Hampstead Residents CLG. (Submission No 111/Case 314724) at An Bord Pleanála Metrolink Oral hearing 12/3/24 (Module 2).

Re:- TII responses to HR CLG Submission Items No 1,2,3,4,5,6,25,26,28 .

Please refer to Map (A). (blue shaded area below).

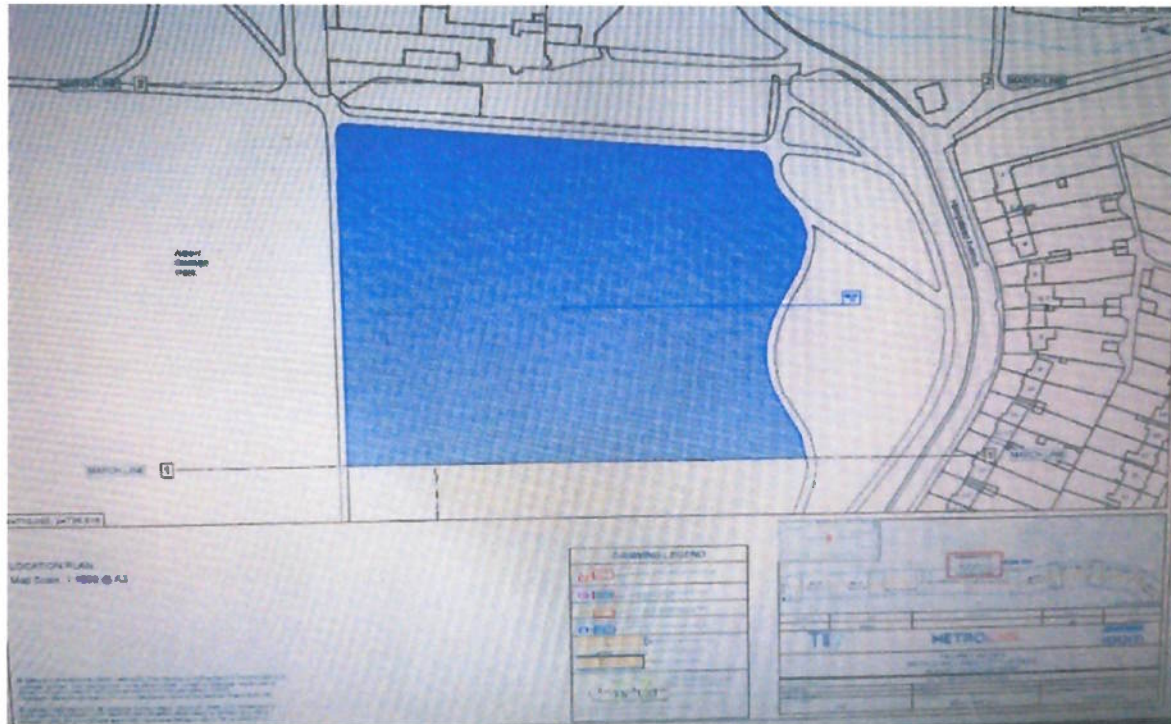
We requested in our submission that any of the soil impacts to Albert College park lands that are indicated by TII/NTA in the above map and specifically allocated for football field re-alignment (according to TII/NTA) are only used for football field re-instatement/re-alignment.

In other words this land should not at any stage be used for temporary construction work , storage, staging, or any support uses, for any Metrolink facility that may occur in Albert College Park.

Unfortunately, TII/NTA have responded with much ambiguity to the above question, in our Oral Hearing, submission Module 1.

We now ask the inspector to include a specific RO condition.

ie:- the land outlined in blue in the above map, should not at any stage be used for temporary- construction work/staging /storage, or any support uses for a Metrolink facility that may occur in Albert College Park.
